P 29743
A Repair

PERMIT

SEWAGE DISPOSAL SYSTEM

MARYLAND STATE DEPARTMENT OF HEALTH

PERMIT CARD New 4/30

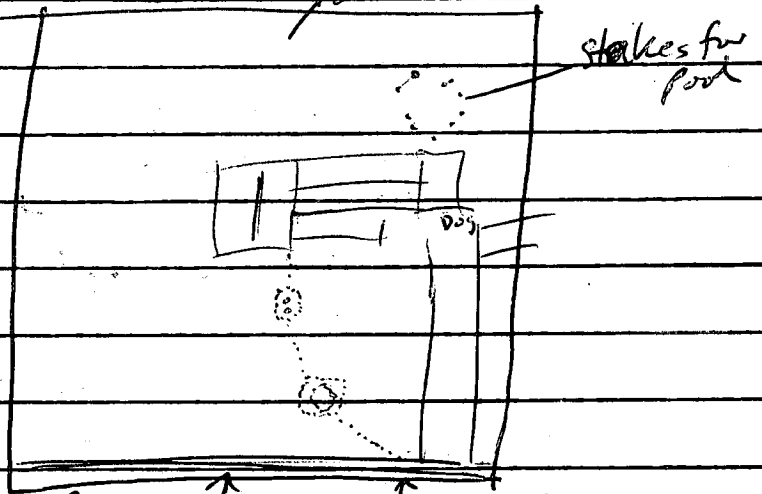
REMARKS 30 Apr 79 - ① - clayey to 24', micaceous SANDY LOAM TO 14'. DEEP TRENCH 60' long, 11' deep with 9' of stone to run with contour toward left prop line. OK to add stone provided owner certifies depth of trench. Call for final trench complete; when old line to drainage ditch removed. GLK 5/2/79 DITCH HAS 3FT COVER

HOMEOWNER NOT HERE NOW LETTER NEEDED FROM OWNER STATING DITCH DEPTH OK TO COVER BUT NO APPROVAL UNTIL LETTER
 DATE SYSTEM APPROVED 3/28/84 INSPECTOR J. Shinn
 as attached Hr

FILE Septic ✓ DATE REPORTED 4/16/79
PROPERTY OWNER Peyton Cole
P.O. ADDRESS 8661 Rt 32 TELEPHONE 730-1489
DIRECTIONS TO PROPERTY 1 mile East of Rt 29.

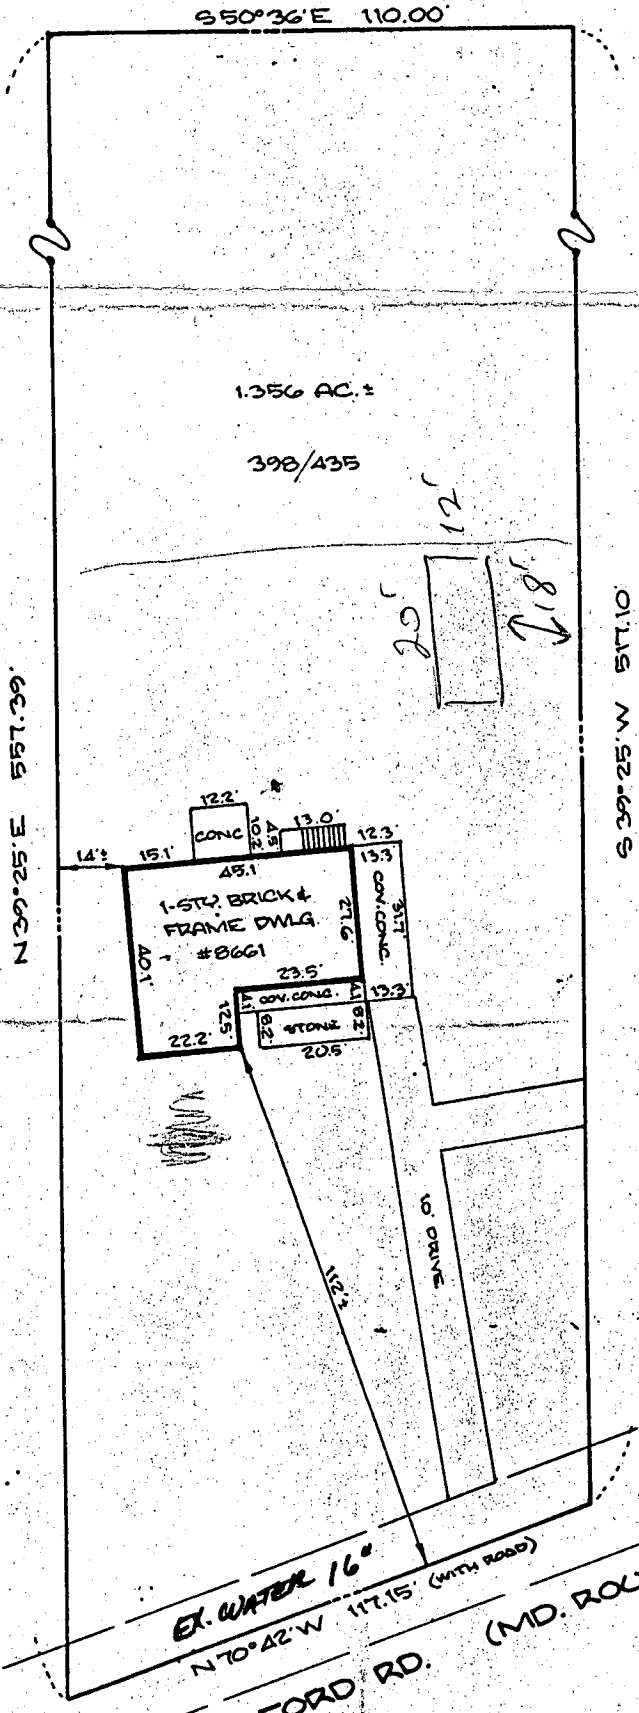
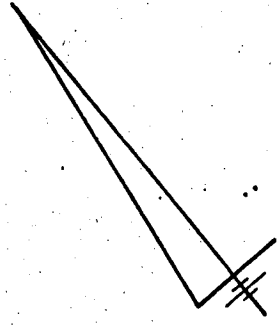
A terra cotta pipe carries a little grey H₂O to the ditch by the ~~dry~~ drive way. It is diagonal at an angle consistent with the possibility it came from the Dry Well. Roof drains do not go down into the ground. Smells like it could be sewage. Dye test may be needed. (118)

ACTION TAKEN 4/18/79 Letter to ^{Cole} ~~Singer~~ Permit denied

until dye test is performed on property in order to determine if the Terra cotta pipe observed next to your driveway. Please call this office & schedule an appointment.
